Customer Service Bulletin

SLM Electronics, Saint Louis, Missouri

CSB0008

Audio Centron ACM-8P

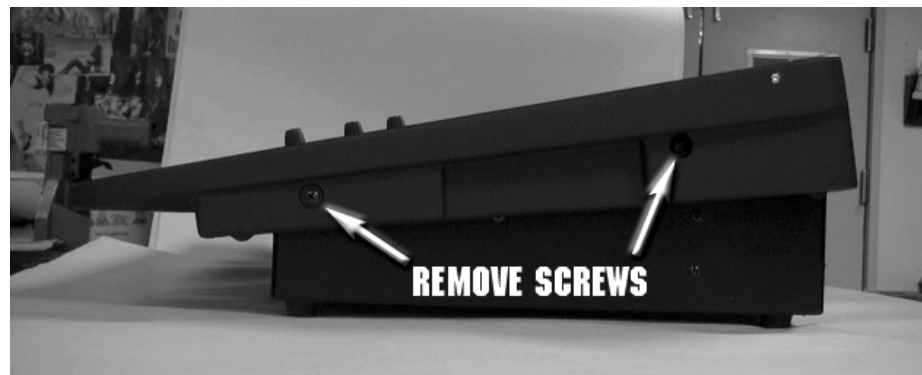
Internal cooling fan may be installed backwards, causing the unit to shut down prematurely under heavy operation.

NOTE: To determine if the fan is installed properly, look at the rear panel of the unit. The fan is on the left side, behind a wire shield. If the fan's label is visible (it may be upside down), the fan is facing the proper direction. To confirm this, plug in the unit and turn it on. Verify the fan is blowing air OUT of the unit, NOT drawing air into it. (A properly installed fan pulls heated air out of the unit.)

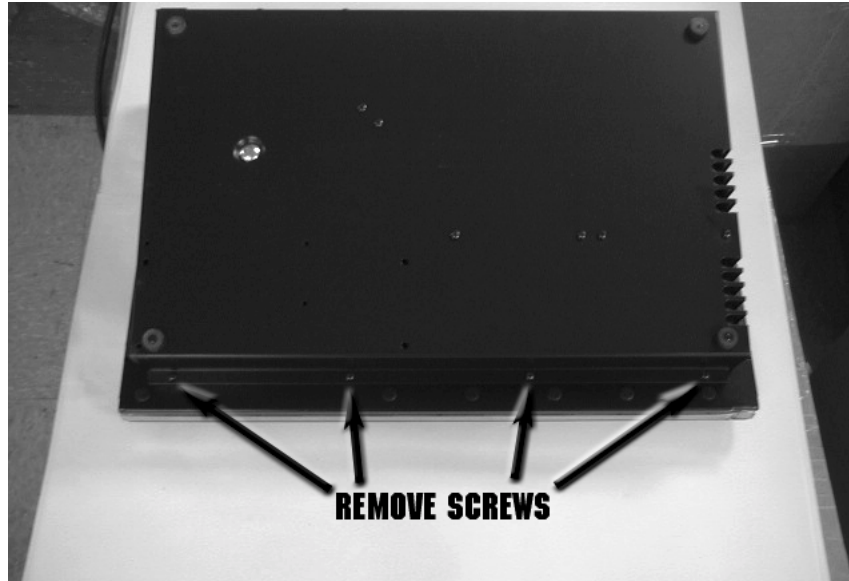
1. Tools needed: #2 phillips screwdriver.
2. Unplug the unit.
3. Remove the two screws from each end piece (see photo below). Remove the end pieces.

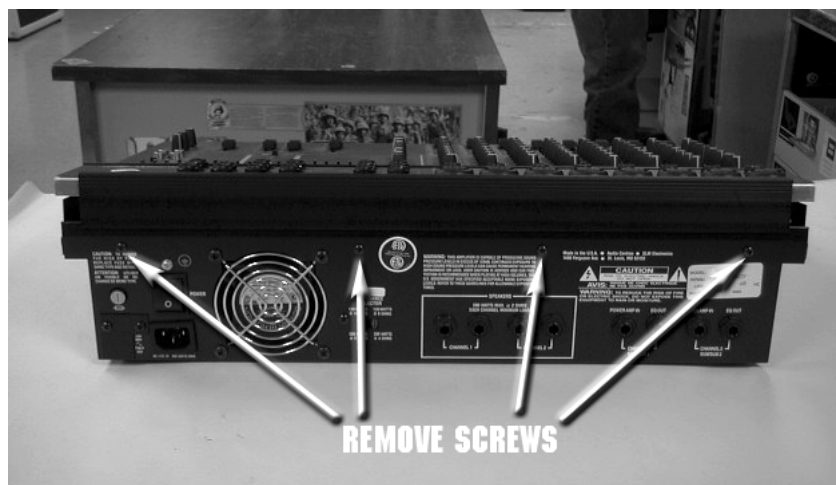
- Carefully flip the unit over. Remove the four screws from along the underside of the unit's front lip (see photo below).
